**RE: Sundance Construction – Beverly Hills
Grading and Drainage Plan
Engineer's Stamp Date: 02/20/18
Hydrology File: B18D023**

**RE: Sundance Construction -Beverly Hills
Grading and Drainage Plan
Engineer's Stamp Date: 01124/18
Hydrology File: 818D023**

This letter is in response to your comments by letter dated January 30, 2018. The comments have been addressed as follows:

C-100

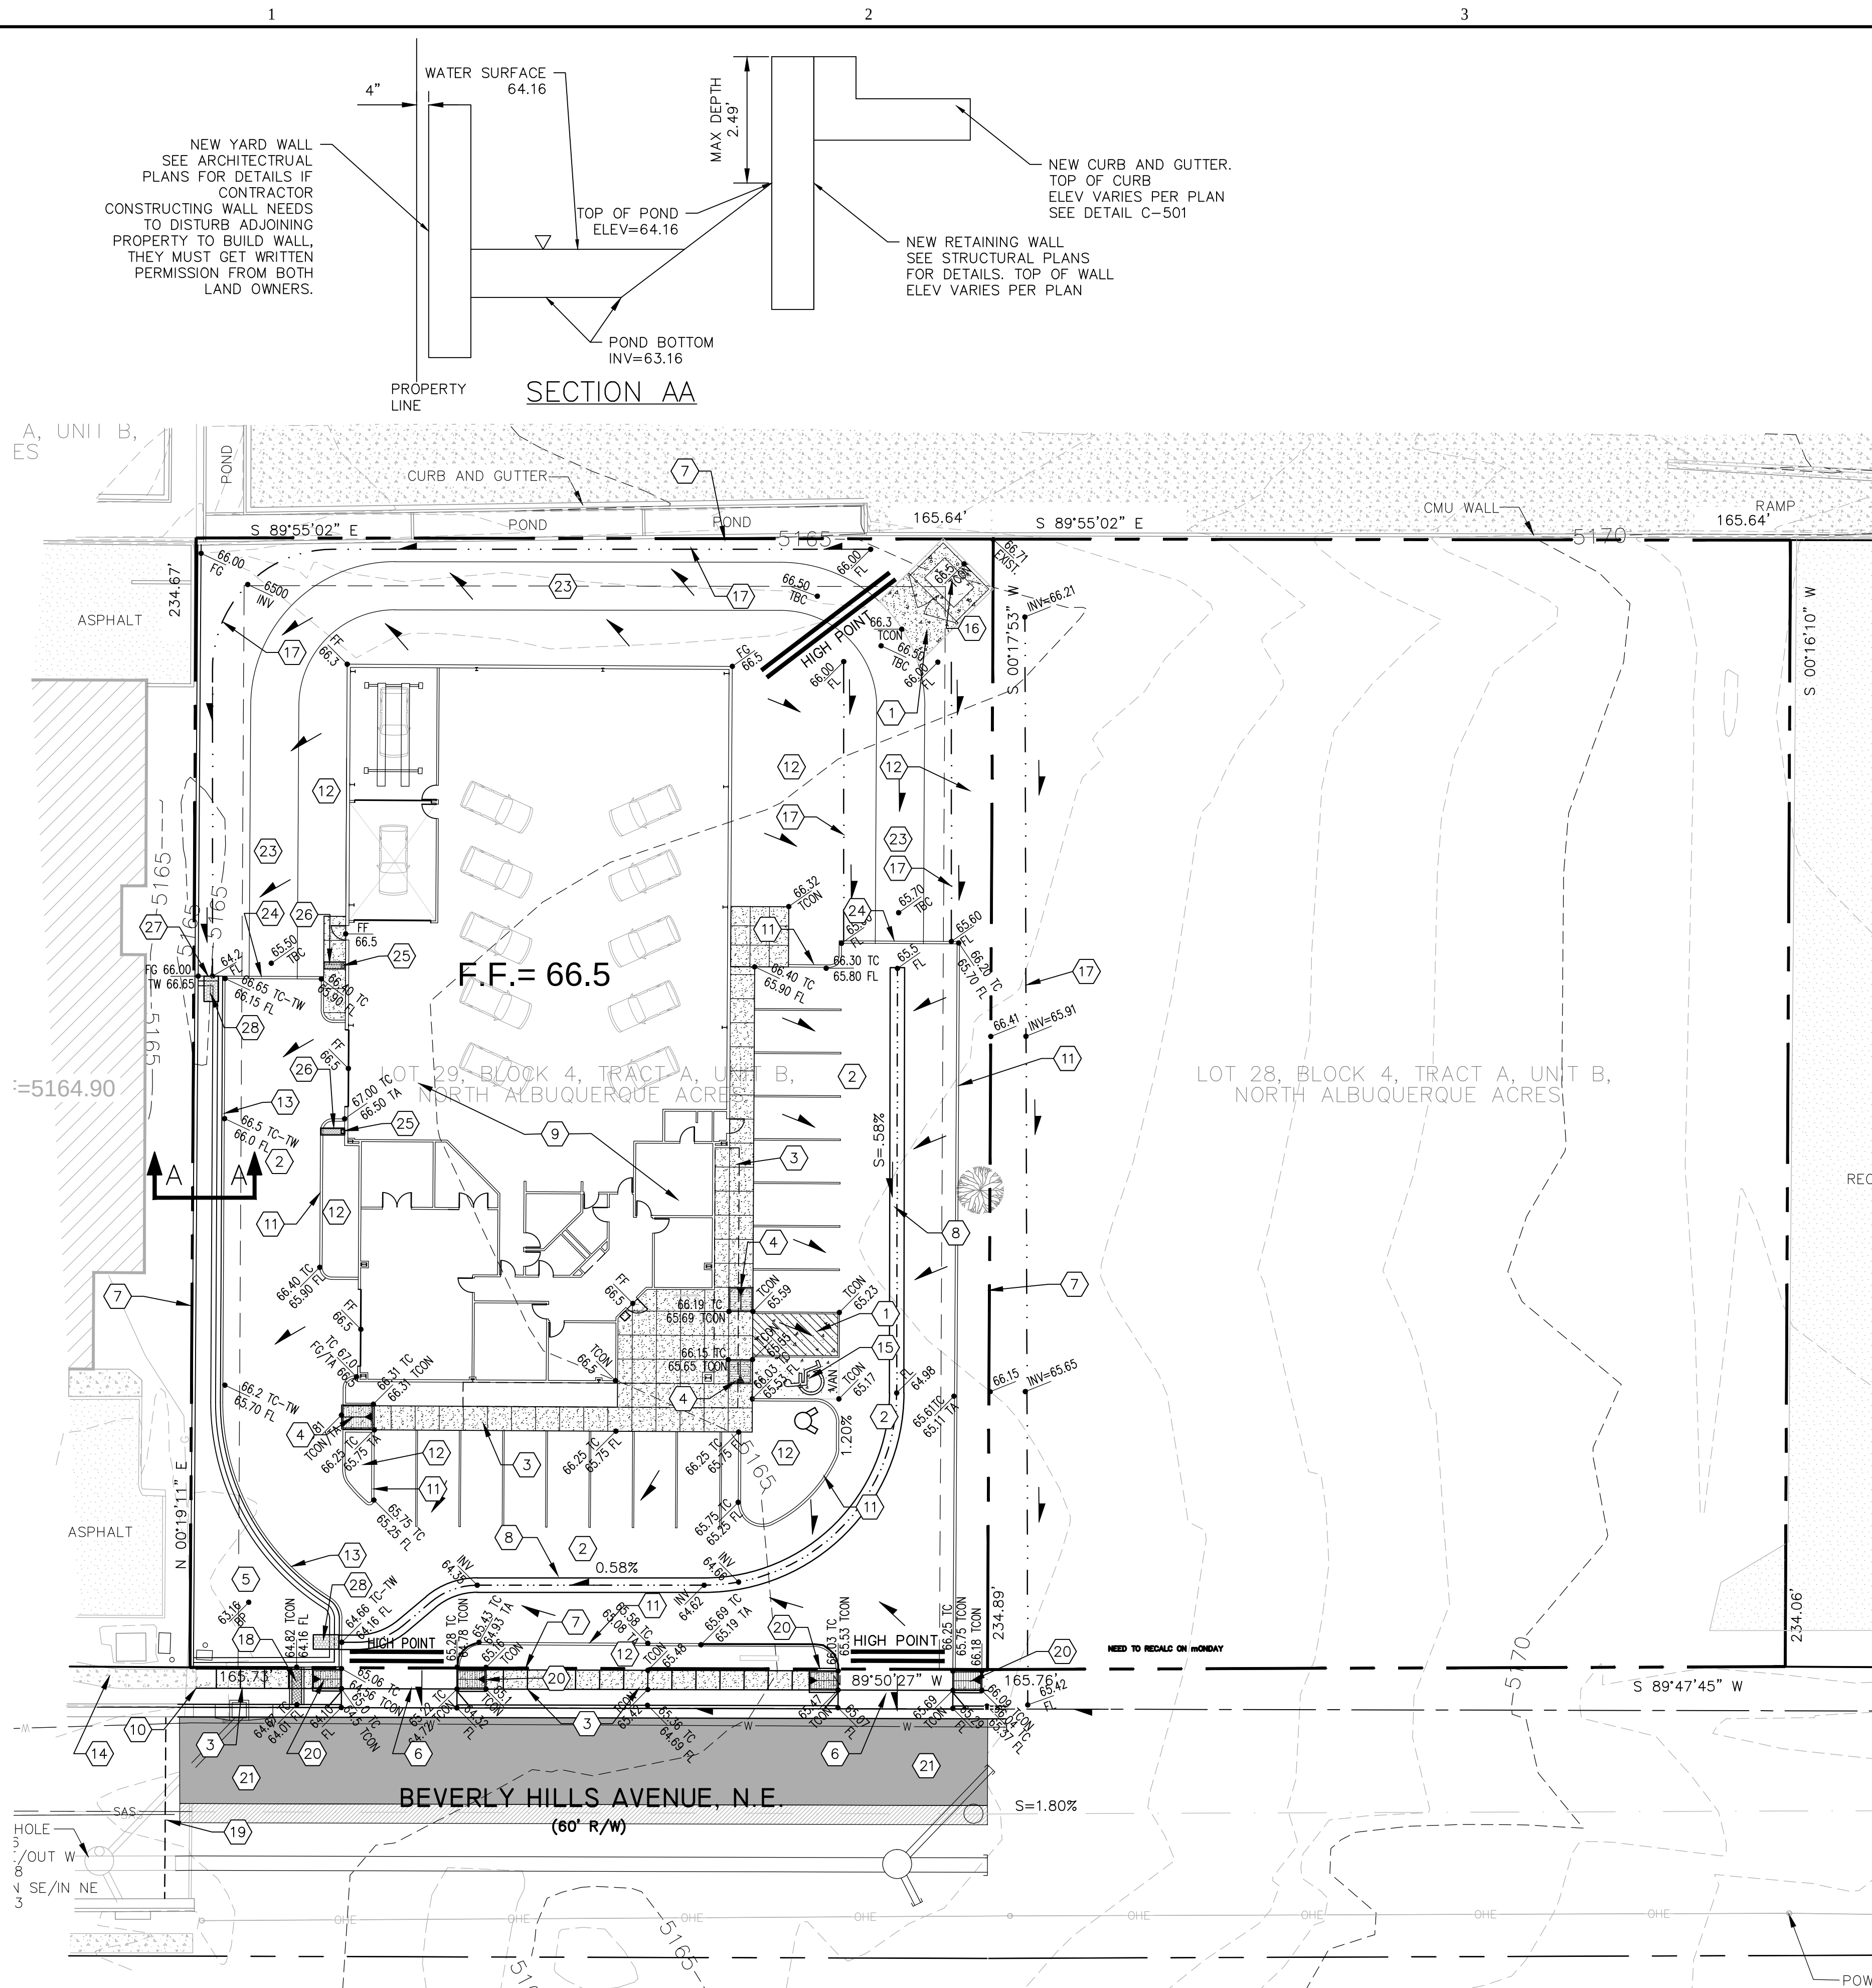
1. Please provide the weir calculations for the curb cuts.

See attached.
